30 Monument Street Single Family Residence  
Project Summary

## Jeanie Bourke - Re: 30 Monument St. Bp#2014-02773

Address/Location of Construction: 30 Monument Street		
Total Square Footage of Proposed Structure:		same
Tax Assessor's Chart, Block & Lot Chart#      Block#      Lot# 16-E-10	Applicant Name: Brewster Buttfield Address 58 Fore Street City, State & Zip: Portland, ME 04101	Telephone: 207-749-7400 Email: brewster@prospectdesign
Lessee/Owner Name: Rich Robinov (if different than applicant) Address:  City, State & Zip: Portland, ME Telephone 207-747-9084 E-mail:	Contractor Name: Cornerstone Build (if different from Applicant) Address: 100 Congress St. City, State & Zip: Portland, ME 04101 Telephone 207-939-0185 E-mail:	Cost Of Work: \$ C of O Fee: \$ Historic Rev \$ Total Fees : \$ 69.00
Current use (i.e. single family) <small>single family</small> If vacant, what was the previous use? Proposed Specific use: <small>single family</small> Is property part of a subdivision? ___ If yes, please name _____ Project description: This is an addendum to permit number BP# 2014-02773. Addition of finished basement, emergency egress well and details on one hour wall.

MONUMENT STREET  
30 MONUMNET STREET  
PORTLAND, ME

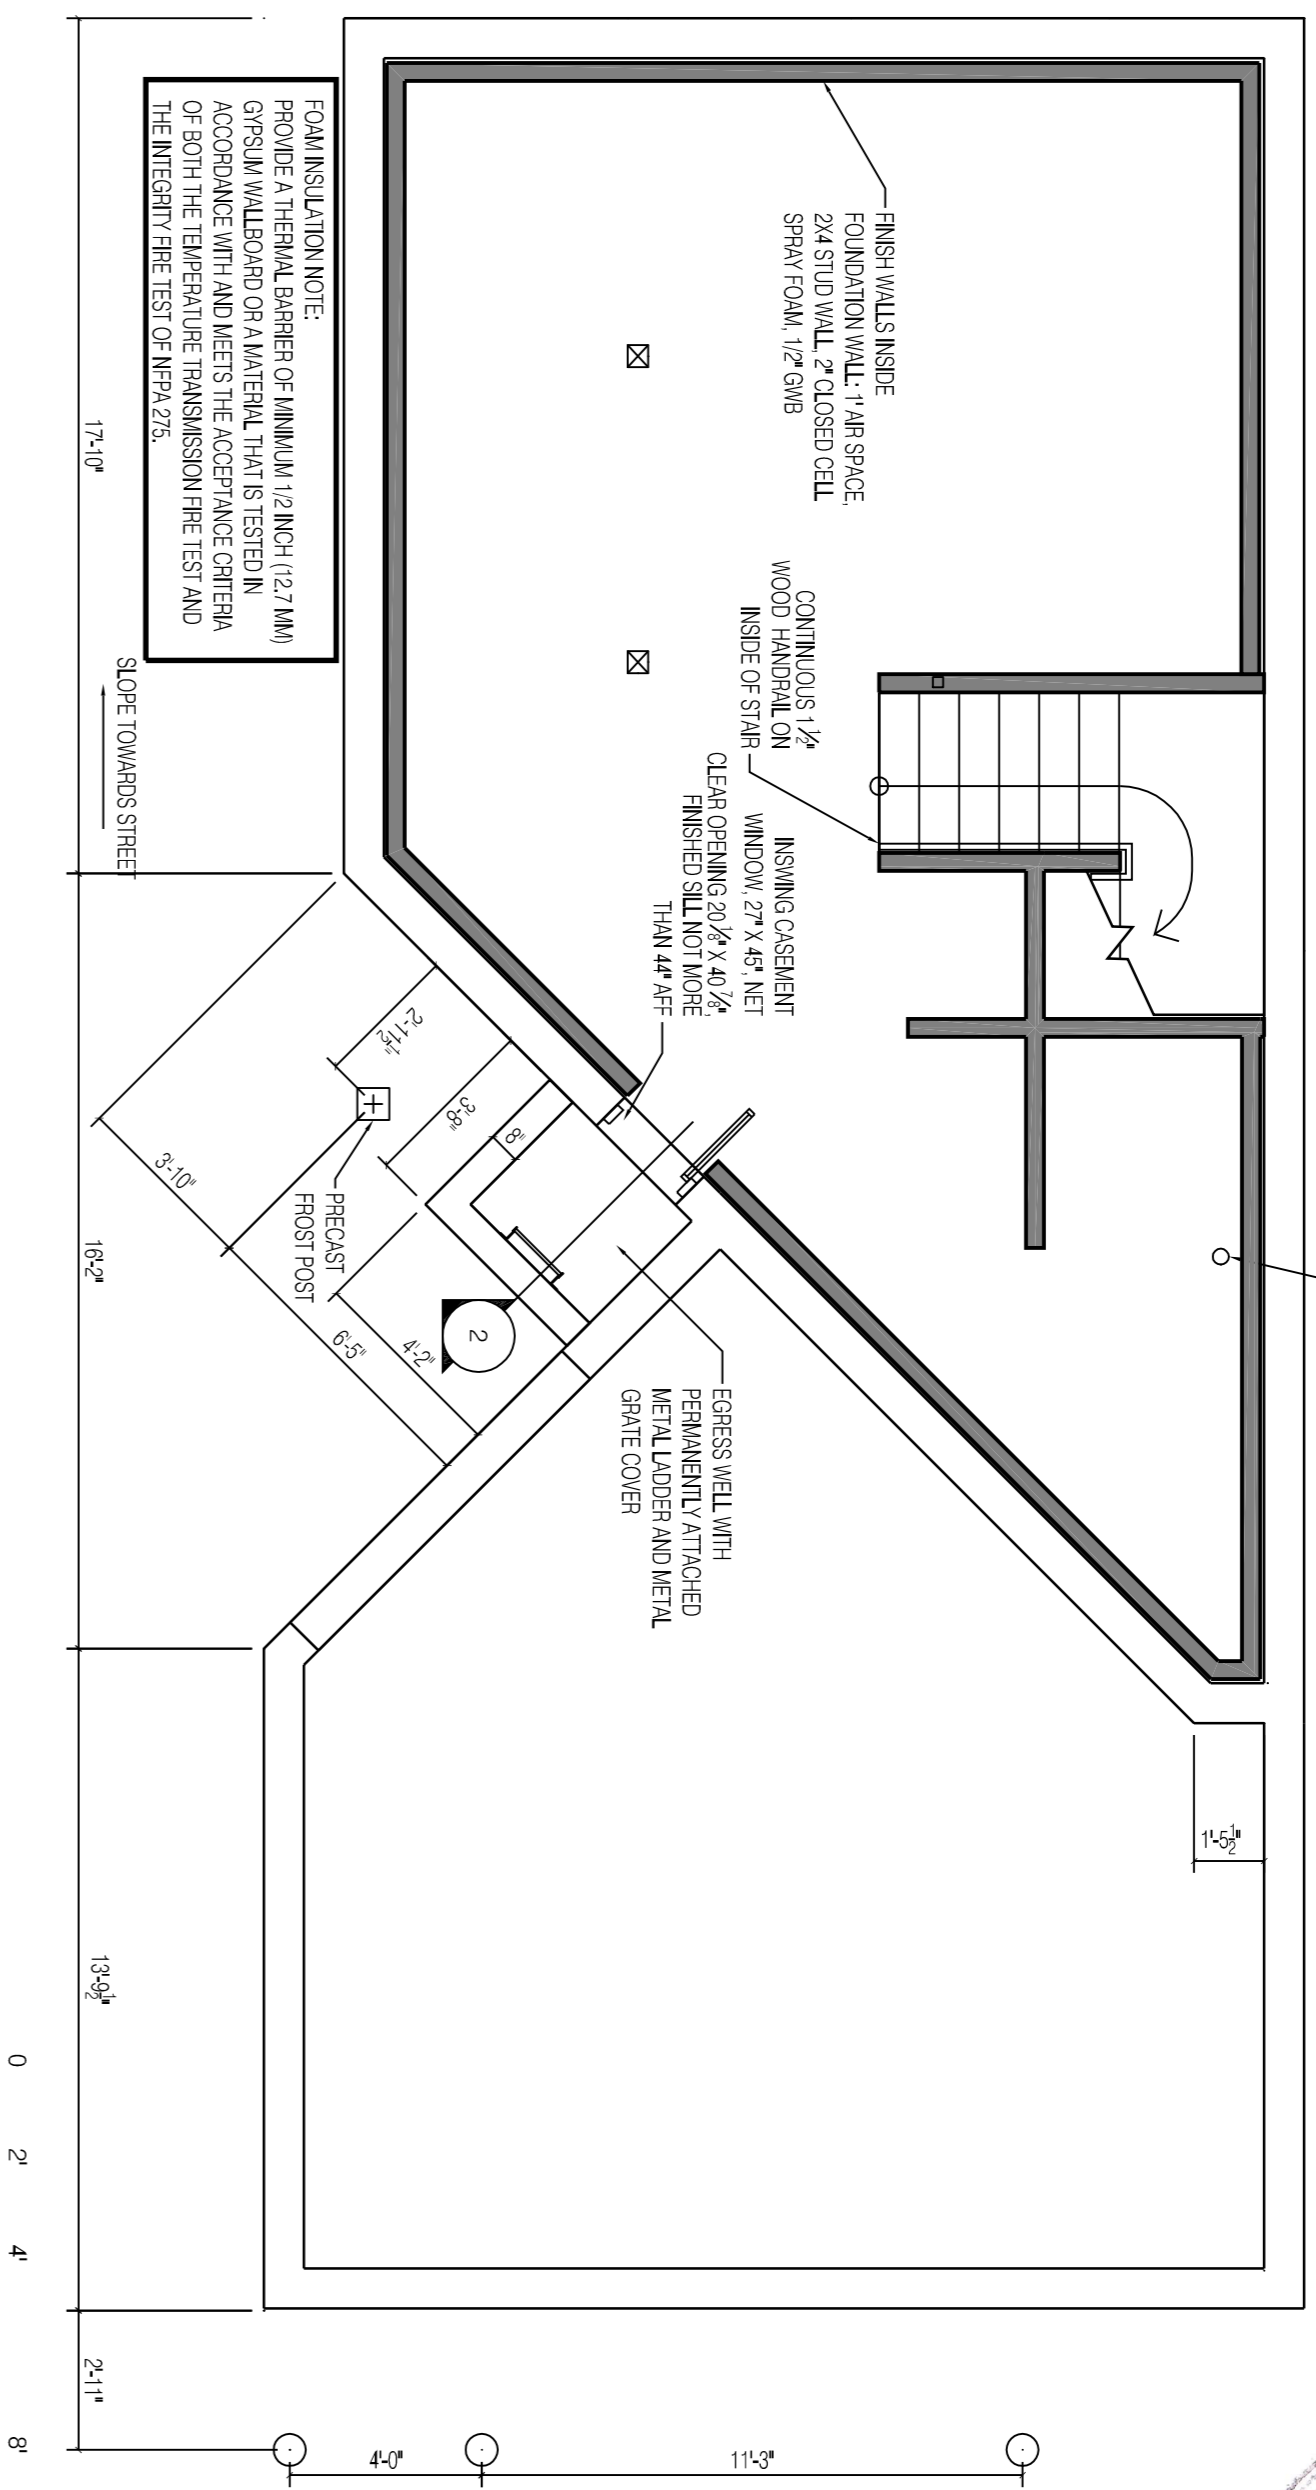
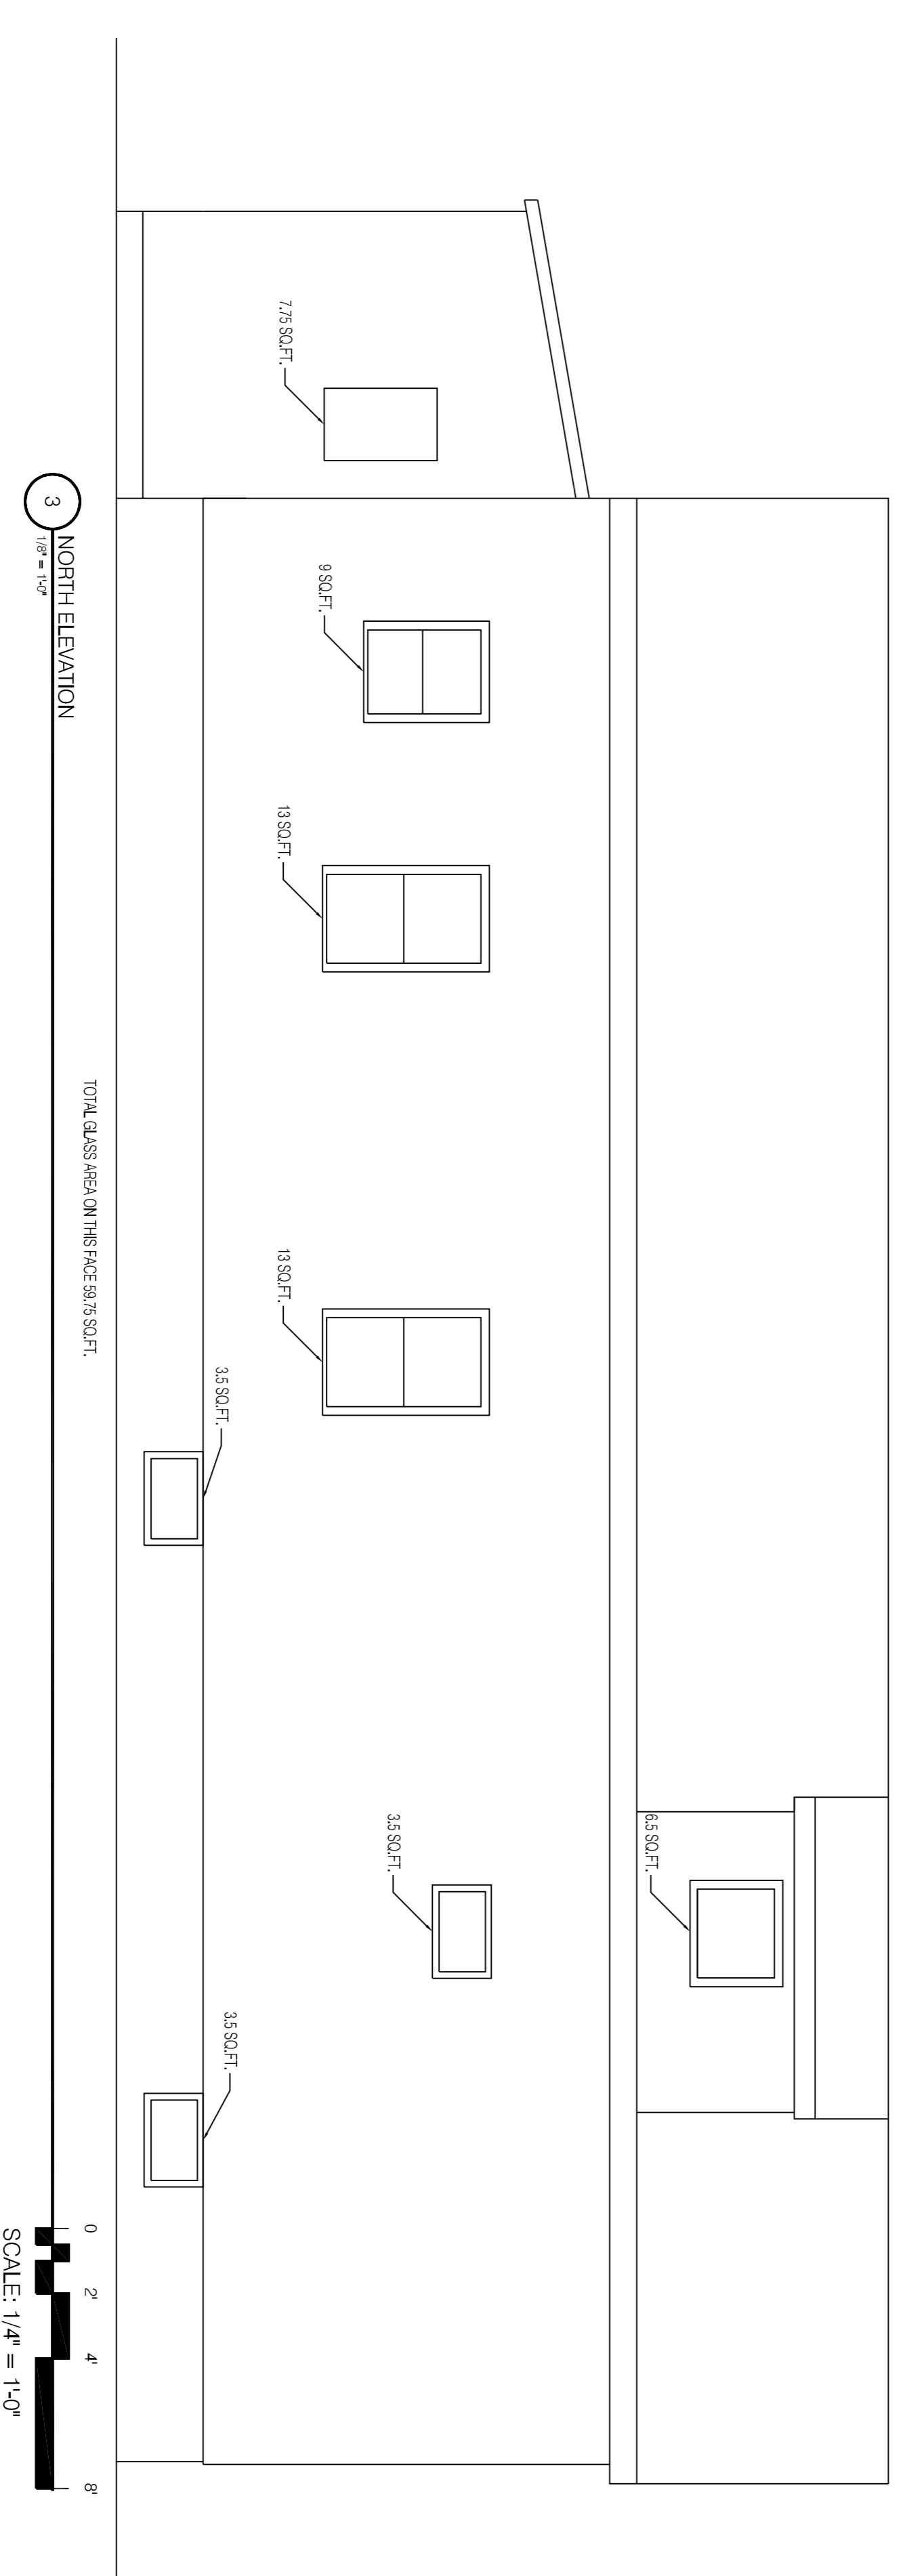
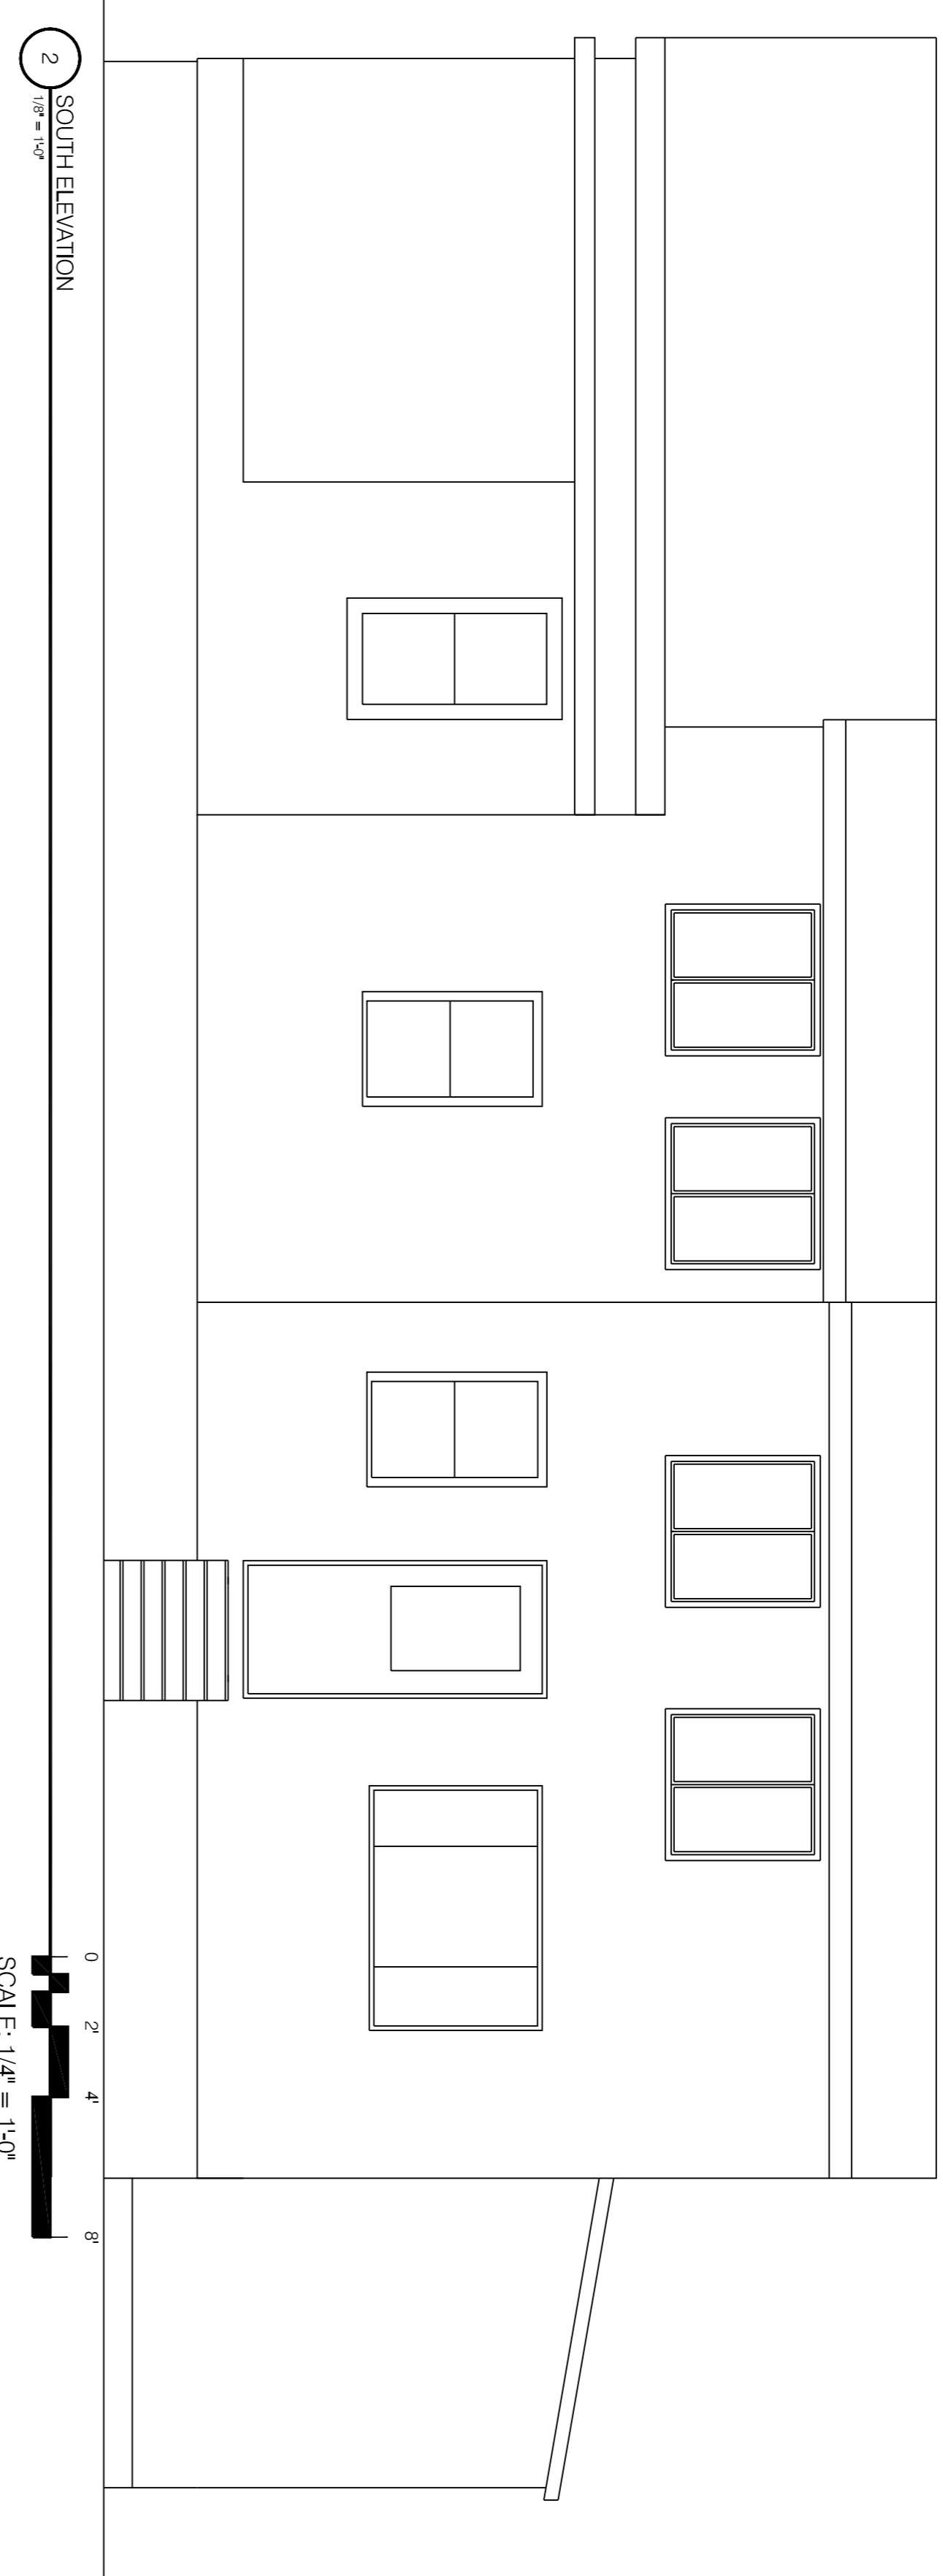
3. An updated plan for the deeper basement is a new sheet, A-103. It shows the required egress well, the stairs to basement instead of a hatch and the required thermal barrier for the insulation. **This, as well as any other changes need to be updated on all associated plans, ie. sections, etc.**

3. Based on the field inspection by George for the footings, it was confirmed with the contractor that the house will have a full basement. If this is correct, an amendment is required for this change and should include the access and emergency escape and rescue opening.
